AES-O-NRC-09-00140-0

AREVA Enrichment Services LLC
Eagle Rock Enrichment Facility
NRC Docket No: 70-7015

Subject: Response to Requests for Additional Information – AREVA Enrichment Services LLC License Application for the Eagle Rock Enrichment Facility

Figure 2. INEL acceleration time-histories from the Borah Peak earthquake displaying the similarity in an envelope of peak amplitudes for TRA, ANL, and CPP.

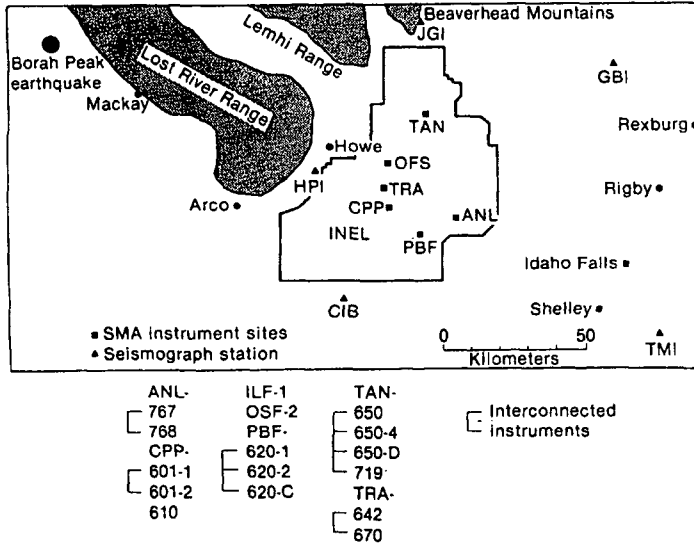
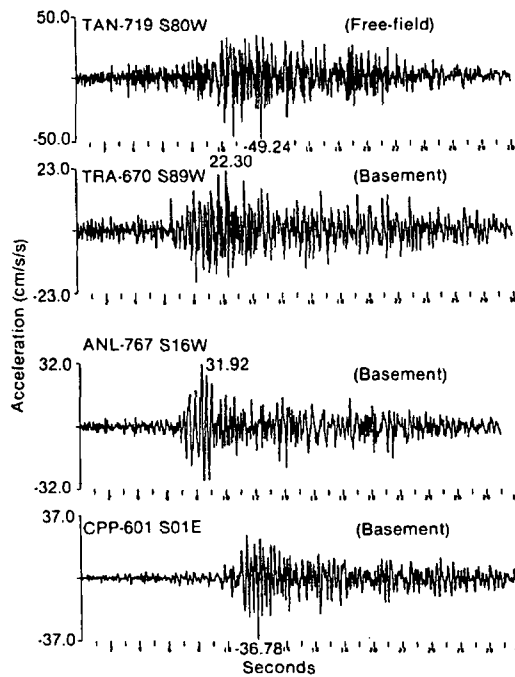
Provide a description of the methodology and the resulting analyses used to develop scaled earthquake time histories.

Results of the site-specific probabilistic seismic hazard assessment for the EREF site include uniform hazard response spectra (UHRS) determined for annual probabilities of exceedance that range from 2.1×10^{-3} to 10^{-5} . The "design response spectrum" for the project will be developed from the site-specific UHRS using a performance based method described in Regulatory Guide 1.208 (US NRC March, 2008) and in ASCE/SEI 43-05 (American Society of Engineers (2005). Certain engineering analyses could require acceleration time histories that closely match the earthquake motion characteristics represented in the frequency domain by the "design response spectrum."

AES will develop response spectra using these time histories to verify that the generated response spectra envelope the DBE Ground Response Spectra (developed by ASCE 43-05 methodology).

USGS Compiled Data Contour Map

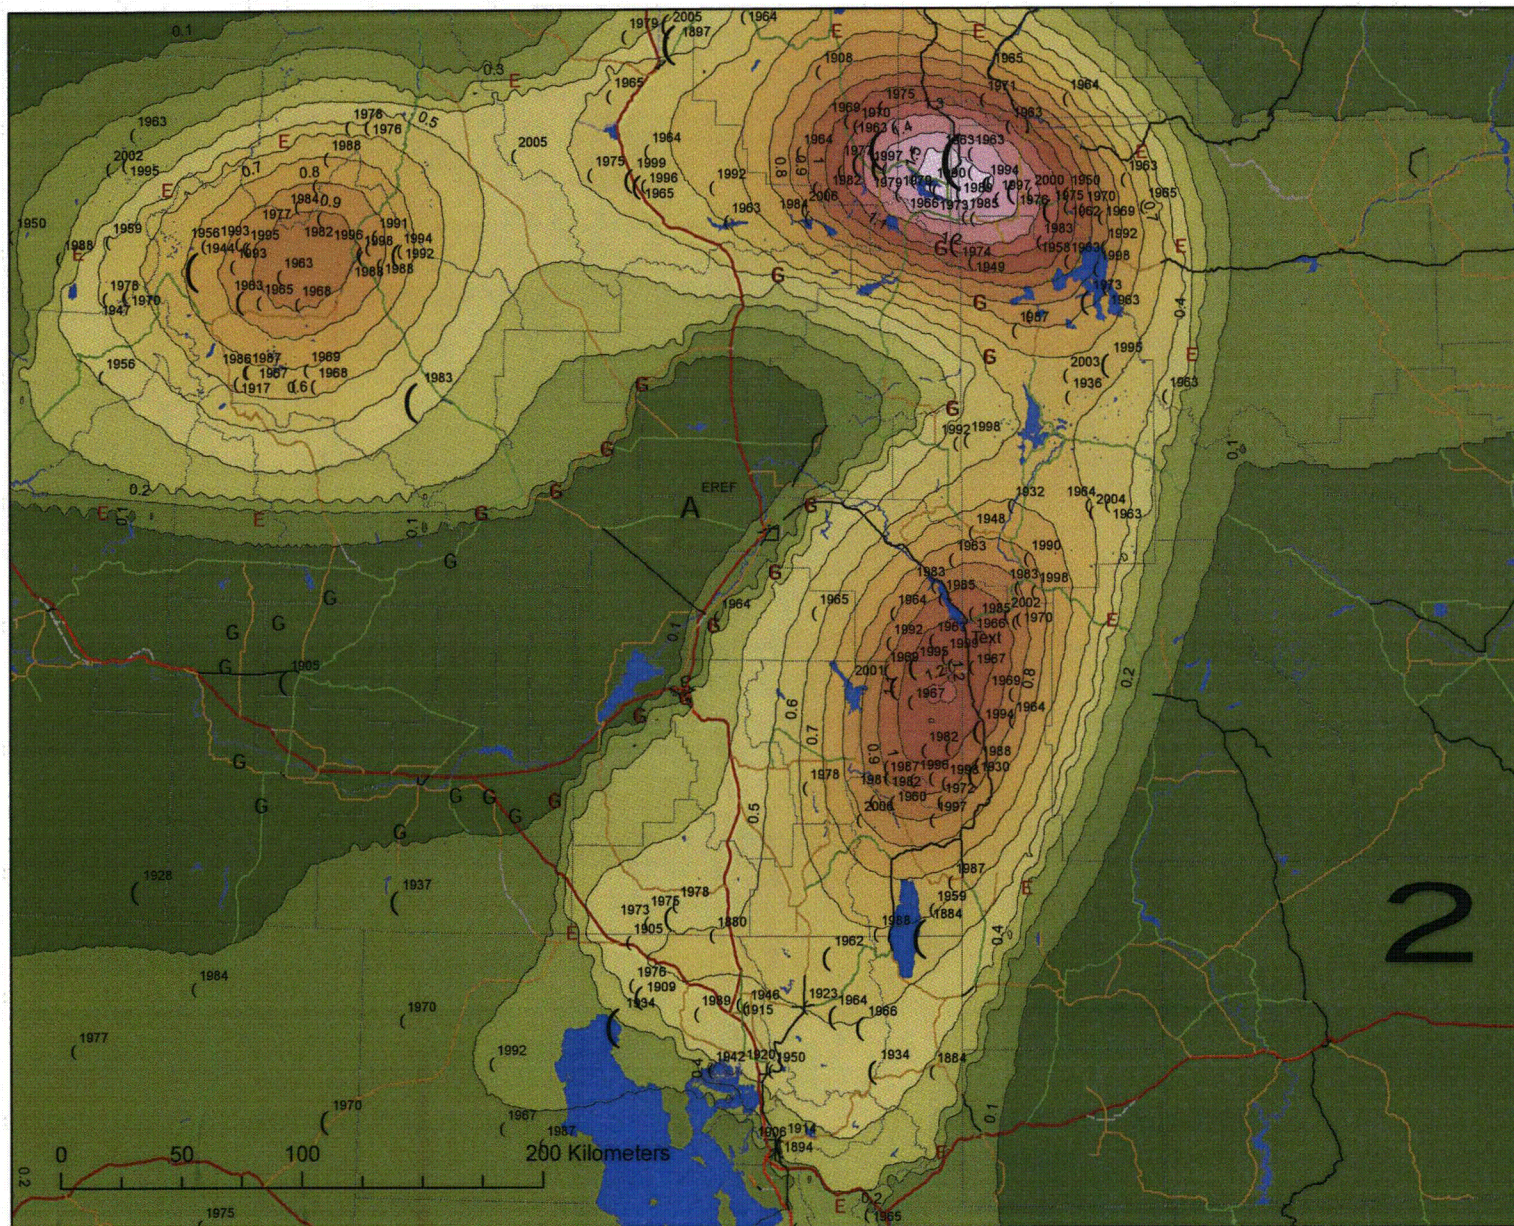
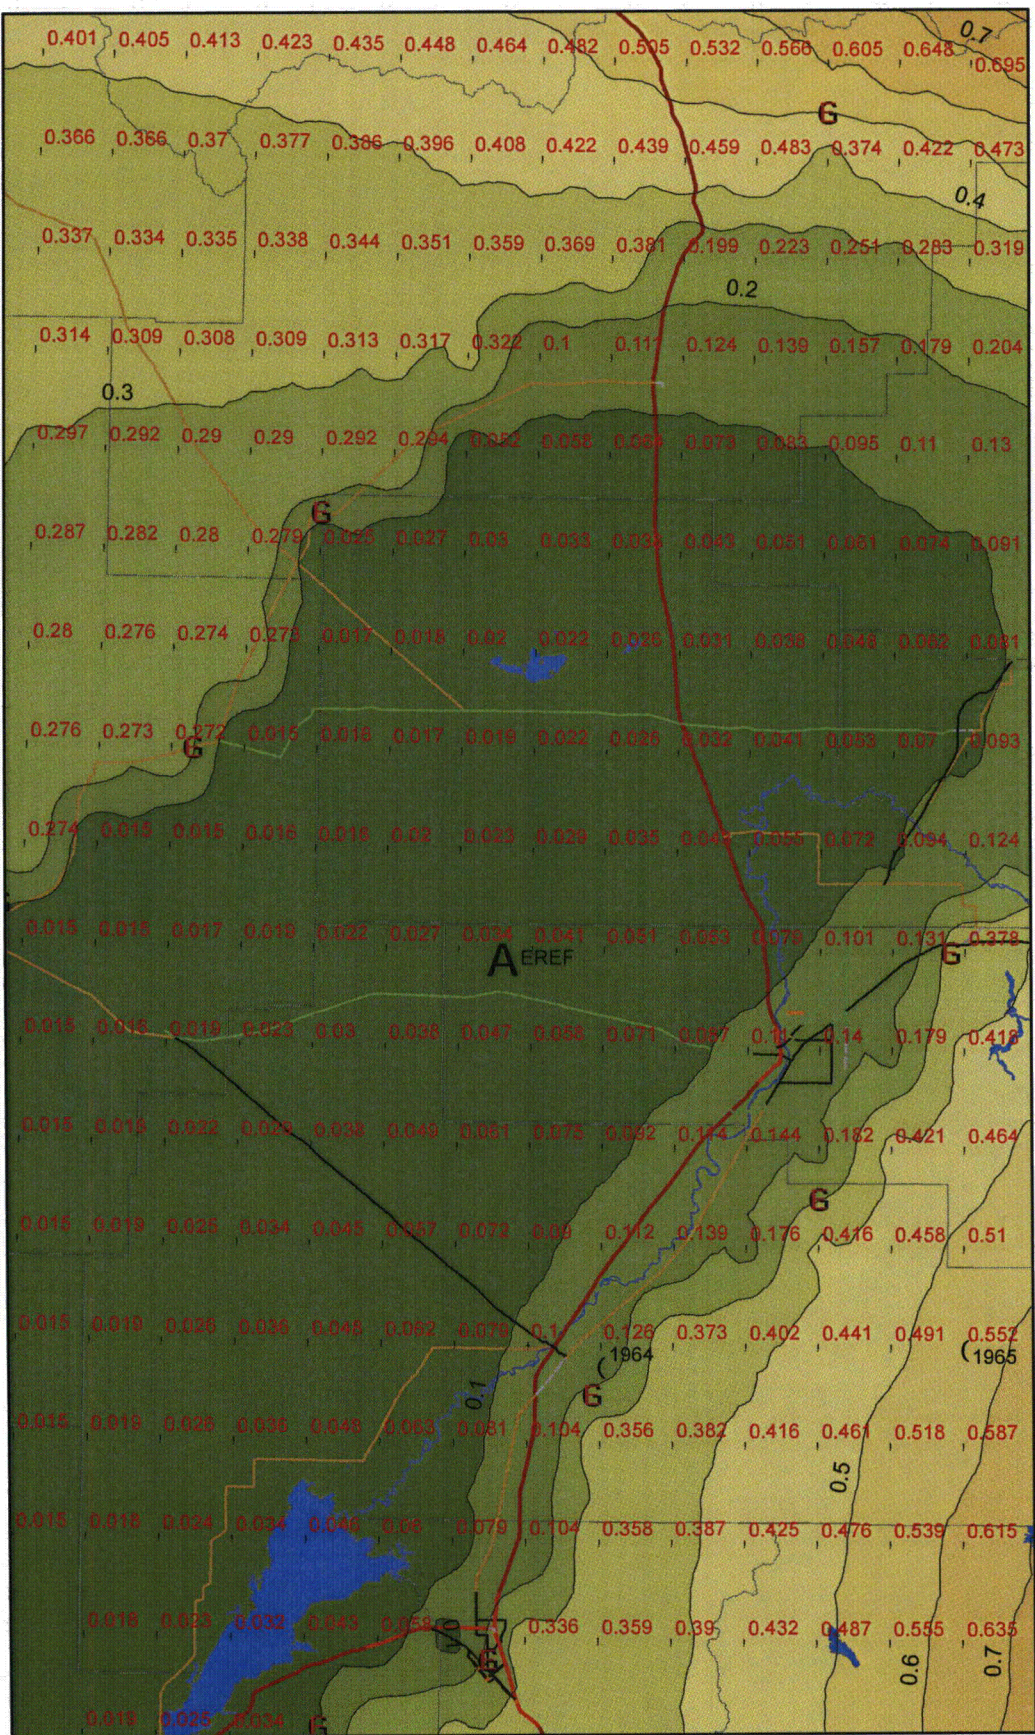
Verify the tentatively worded conclusions in the Environmental Report and Appendix F that explain why the applicant's seismic hazard assessment results in smaller ground motion amplitudes than the ground motions the U.S. Geological Survey predicted in the 2008 U.S. National Seismic Hazard Maps.

Figure 1 (Attachment 1) shows a map prepared using the following USGS (2008, 2009) information.

Figure 1 (Attachment 1) includes a contour map calculated from the data file (Item 2.) of USGS (2008) gridded a-values. The agrd.out.txt includes earthquake activity rates for cell sizes of 0.1° Latitude and 0.1° Longitude. The rate of earthquakes of magnitude -0.5 to 0.5 centered at magnitude 0 is determined as 10^{agr_d} . The rate of earthquakes at higher magnitudes is determined using the uniform b-value of 0.8 used in USGS (2008) throughout the region shown on Figure SP-8-1. Figure 2 (Attachment 2) shows the gridded a-value locations with annotated a-values. Gridded a-values for the EREF site region range from 0.034 to 0.058 with a value of 0.0406 interpolated for the EREF site location. The grid cell area for the EREF site region is 89.7 sq. km. Figure SP-8-2 illustrates that the gridded a-values range from a low value of 0.015 about 40 km northwest of the EREF site near the western boundary of the ESRP with the Yellowstone Parabola zone to a high value of 0.182 about 40 km southeast of the EREF site near the contact with the eastern branch of the Yellowstone Parabola.
